**ROCKSPRING-POWELL PLACE
POWELL STREET AND WEST ROCKSPRING STREET /
DENVER STREET AND HALL STREET
VANCE COUNTY HOUSING AUTHORITY
HENDERSON, NORTH CAROLINA**

ADDENDUM No. 2

Radon-Ready House/Passive Mitigation Slab Detail

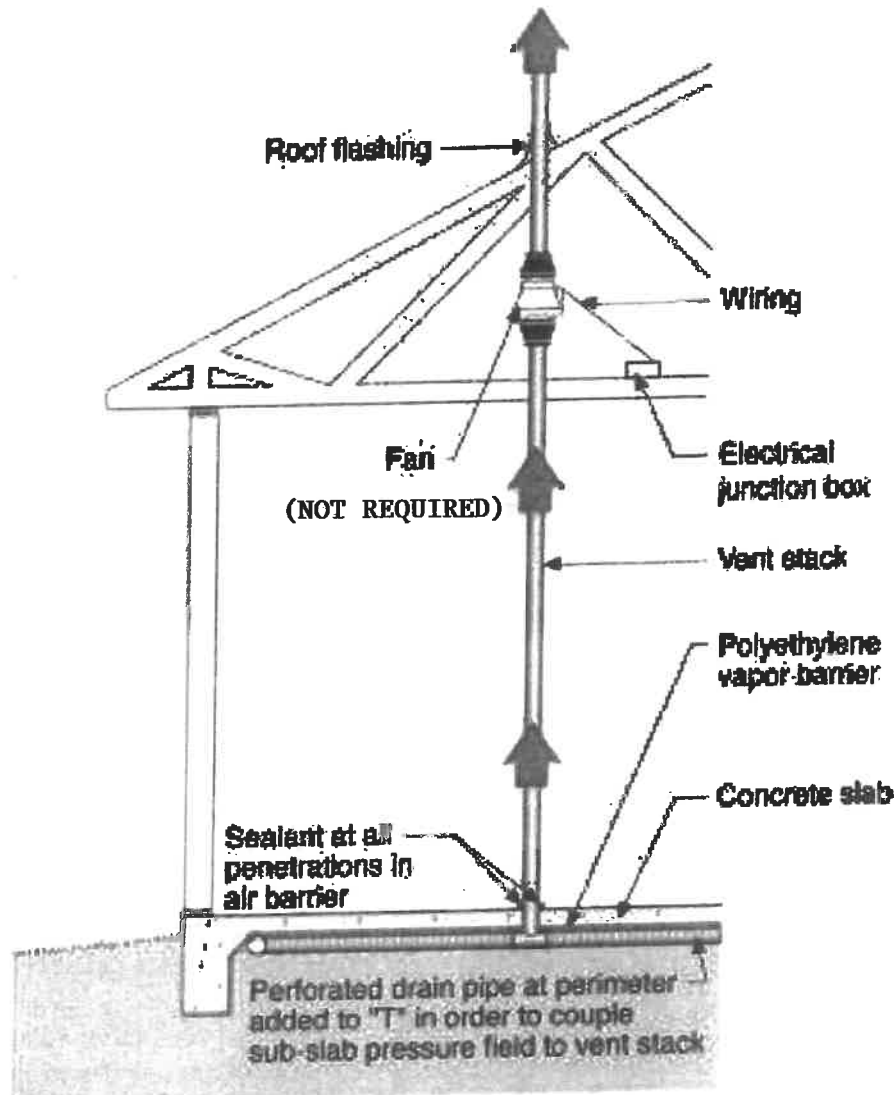
- A. Sheets A-2, A-5, A-9 and A-12.
 - 1. Radon-Ready Mitigation System.
 - a. Perimeter drainpipe shall be vented thru roof as per attached detail (**See Exhibit "A"**). Provide junction box with #12 wiring back to electrical panel box. Fan not required.

9.3. Install a 3-4 inch diameter PVC pipe T-fitting from below the crawl space liner or slab. Connect it to a pipe that runs vertically through the house and exhausts to the exterior a minimum of 12 inches above the roof and 10 feet from openings into conditioned spaces. Install a power supply accessible to the upper top 50% of the pipe in case there is a need to convert to an active radon system.
